Terrace Guardrail Update

Children's Museum of Manhattan

March 19, 2025
Post Approval Amendment

Terrace Plan - Mesh Guardrail

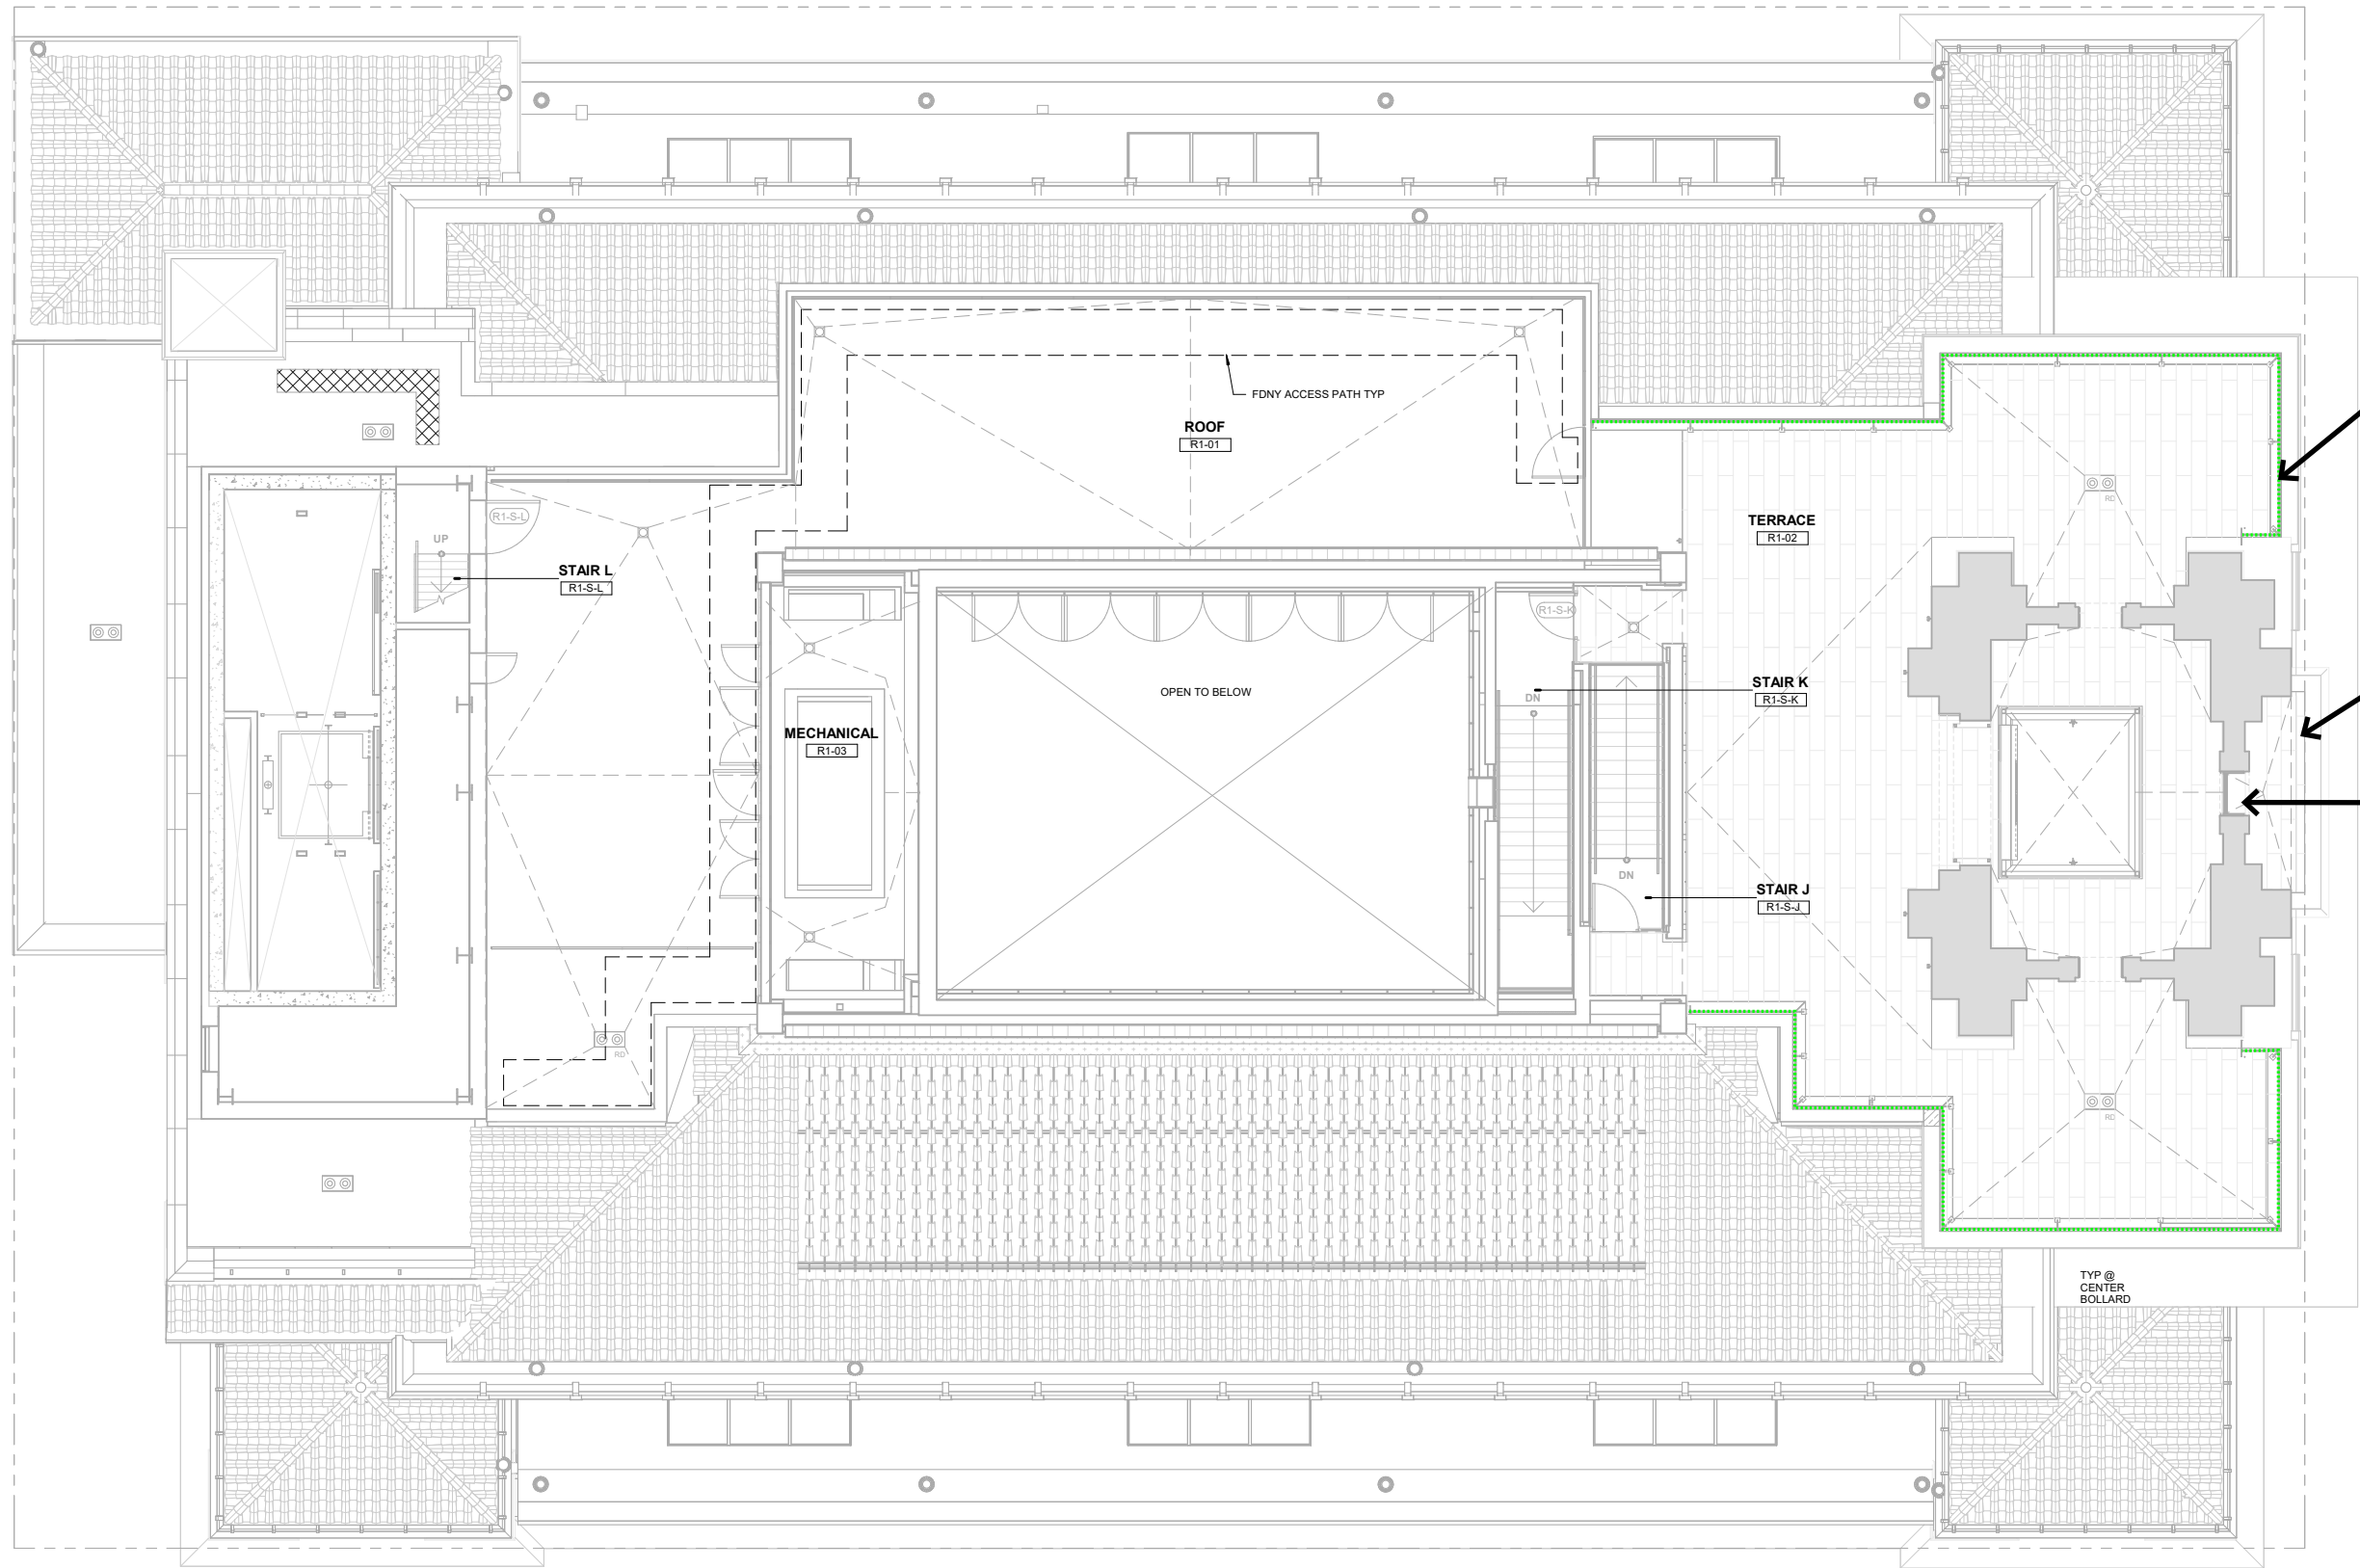
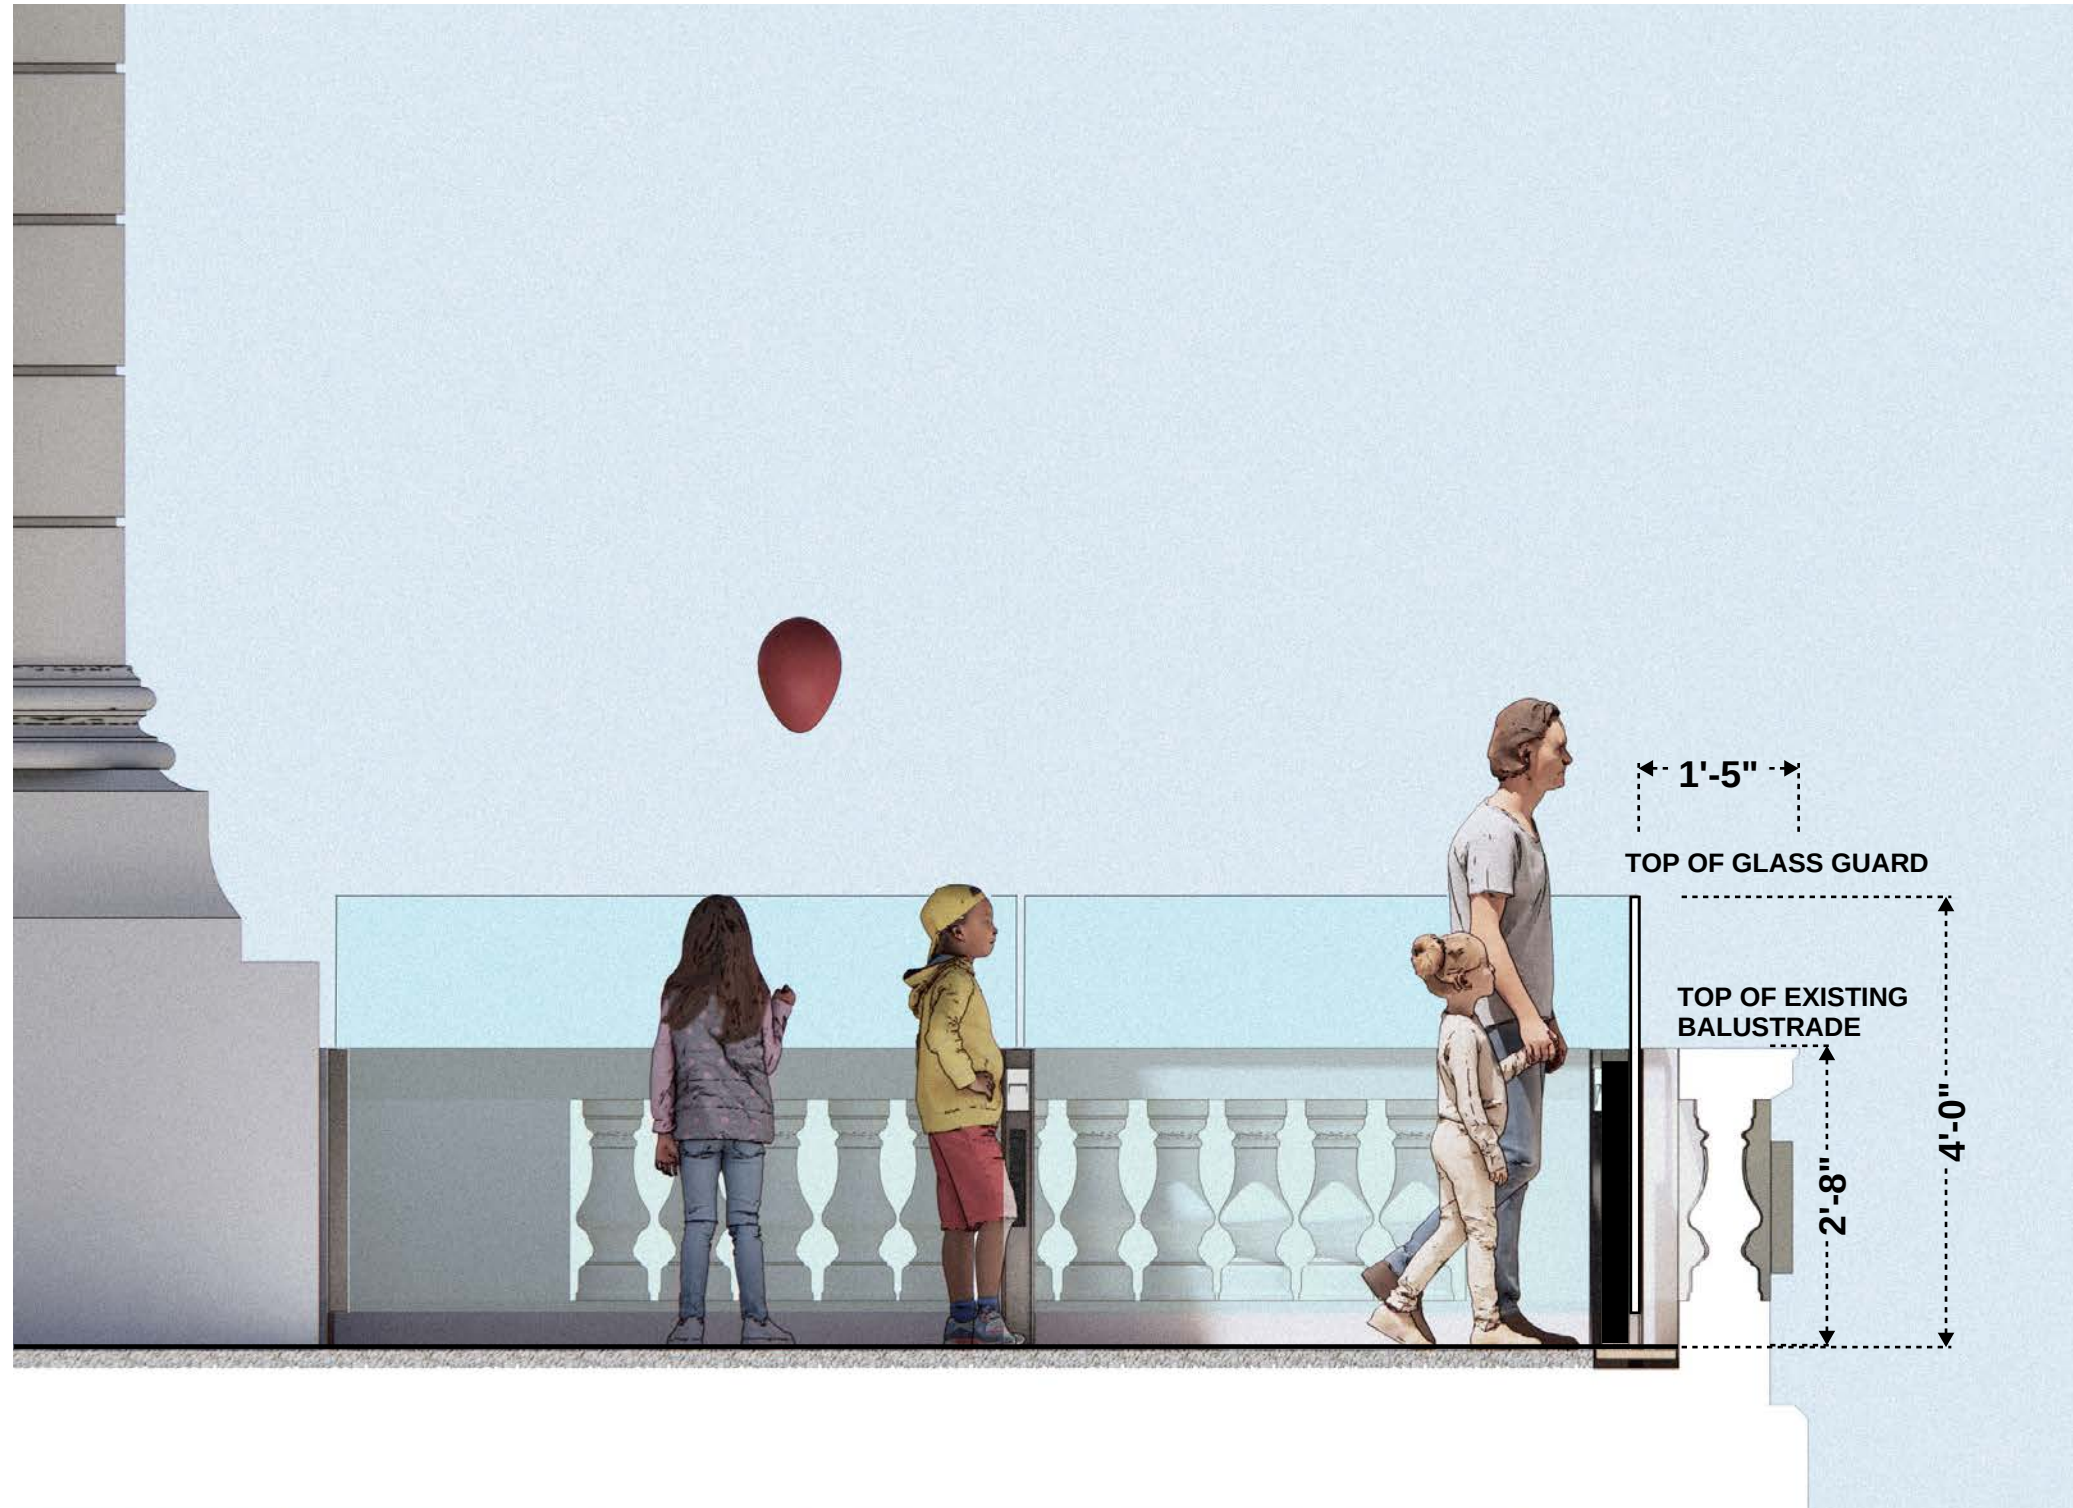
- **Increase guardrail height on the Terrace from 4'-0" to 6'-0" minimum, to address safety concerns**
- **Proposed design includes a stainless steel mesh with minimal frames integrated with the bollards and integrated light standards, simply designed**
- **Mesh is a contemporary intervention, clearly a new element, distinct from the granite tower and balustrade, with small enough apertures to deter climbing**
- **Mesh enhances the visitor experience on roof - feel breeze instead of being enclosed in glass**
- **Mesh is less reflective than glass and safer for birds**
- **Railing at center balcony is removed, a stainless steel frame and mesh gate is added to the center doorway for FDNY access only**
